SUBJECT: ADMINISTRATION AND EARLY LEARNING CENTER ADDITIONS
ORCHARD FARM R-V SCHOOL DISTRICT
ST. CHARLES, MISSOURI
PROJECT # 23-09C

ORCHARD FARM R-V SCHOOL DISTRICT
ADMINISTRATION AND OFFICE ADDITIONS
ST. CHARLES, MISSOURI

JULY 23, 2024

The drawings and specifications are hereby supplemented and amended to include the following particulars:

CLIFFORD L. HEITMANN
LICENSE #E-29817
ENGINEERING CORP.
NO. 000655

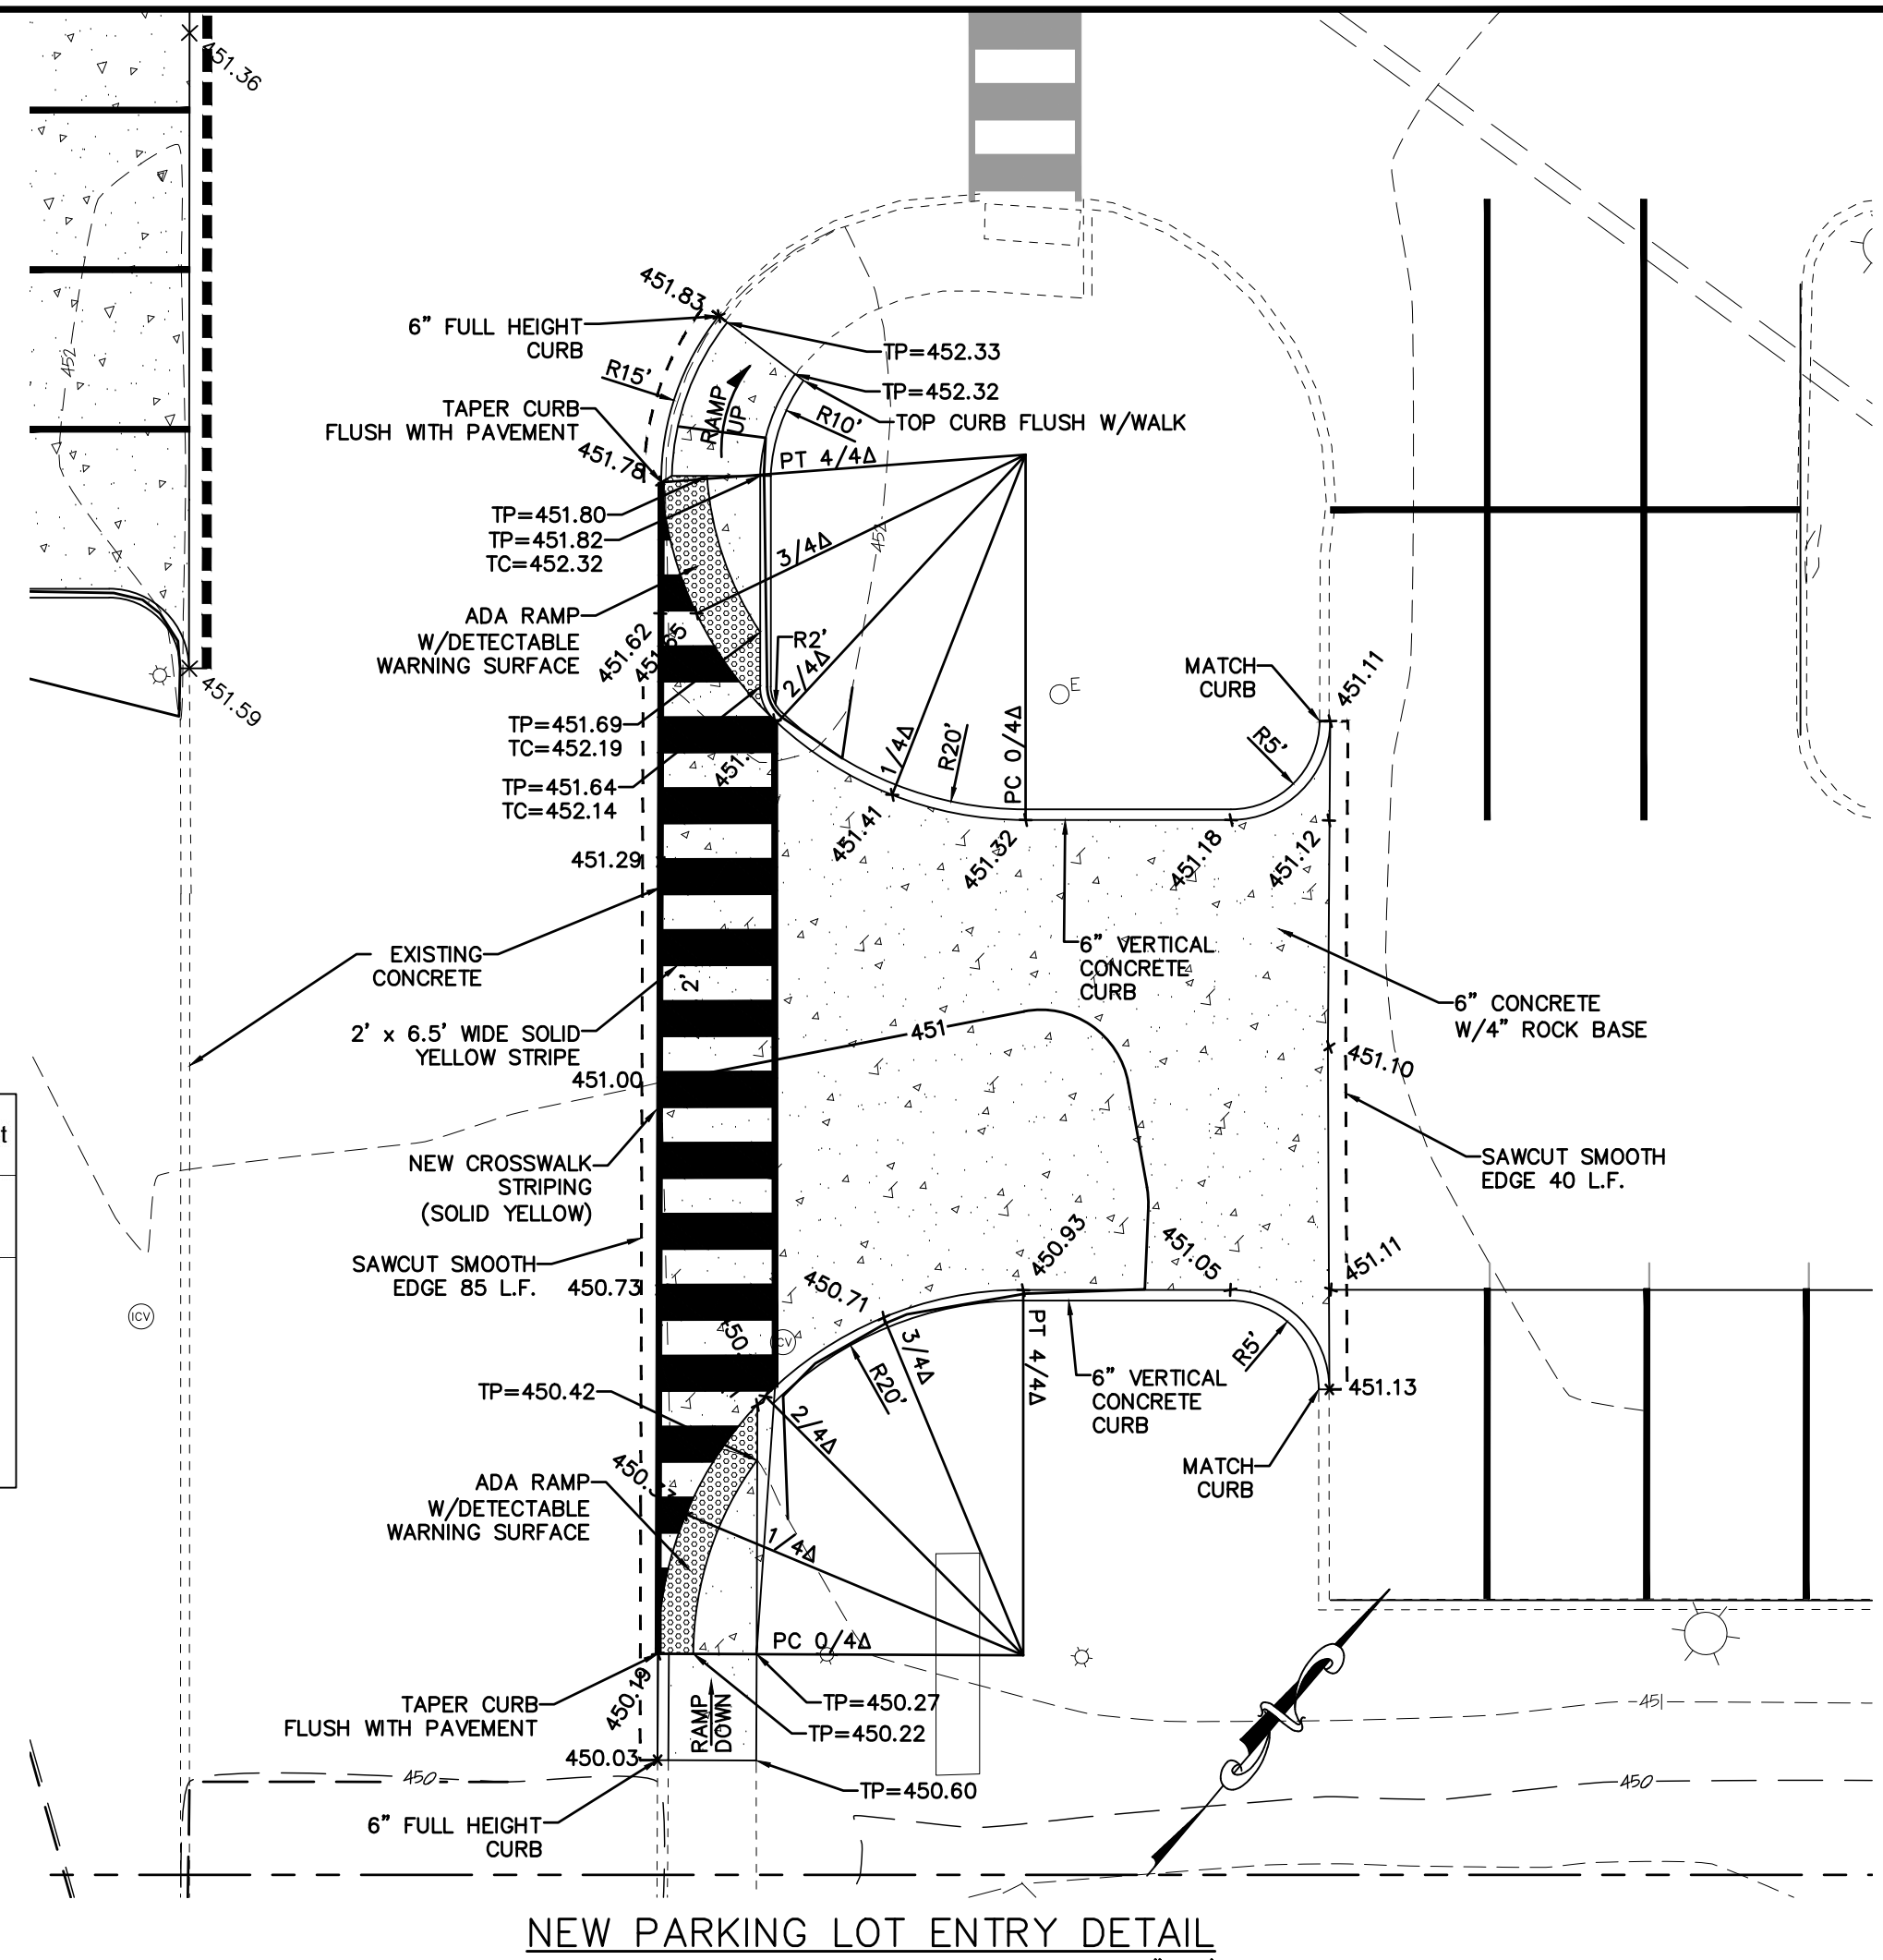
ITEM NO. 3: CIVIL DRAWING C7.00

- A. **“ADD”** Supplementary Drawing No. SD 4, dated July 23, 2024 included with this Addendum, and hereby made a part of the Contract Documents that shows added to pavement remediation detail.
